# UNITED STATES PATENT AND TRADEMARK OFFICE

APPLICATION NO.	FILING DATE	FIRST NAMED INVENTOR	ATTORNEY DOCKET NO.	CONFIRMATION NO.	
10/624,542	07/23/2003	Man Chi Li	402725	7495	
23548 75	590 10/19/2004		EXAM	INER	
LEYDIG VOIT & MAYER, LTD 700 THIRTEENTH ST. NW			KLAUS, LIS	KLAUS, LISA NHUNG	
SUITE 300		ART UNIT	PAPER NUMBER		
WASHINGTON, DC 20005-3960			2832		
			DATE MAILED: 10/19/2004

## **DETAILED ACTION**

FIG. 2

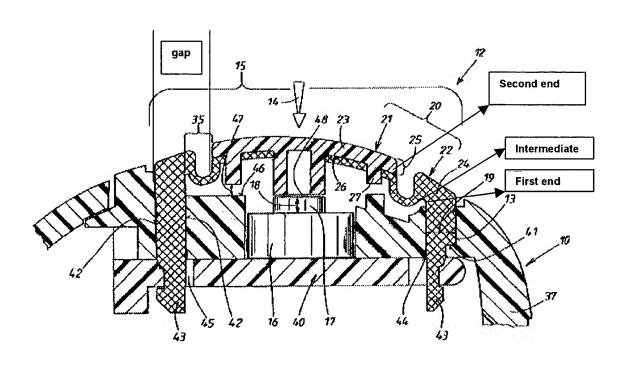
- the seal 22, 30 has an intermediate portion (see the attachment) between the

opening and the actuator, the portion being folded and having a reduced thickness;

- the seal 22, 30 comprises a sleeve 29, 39 having opposite ends connected to

the opening (see the attachment) and the actuator cap 21 respectively, a first of the

ends (see the attachment), being disposed around the corresponding one of the

opening and actuator cap 21;

- the second end (see the attachment) is also disposed around the other of the

opening and actuator cap 21;
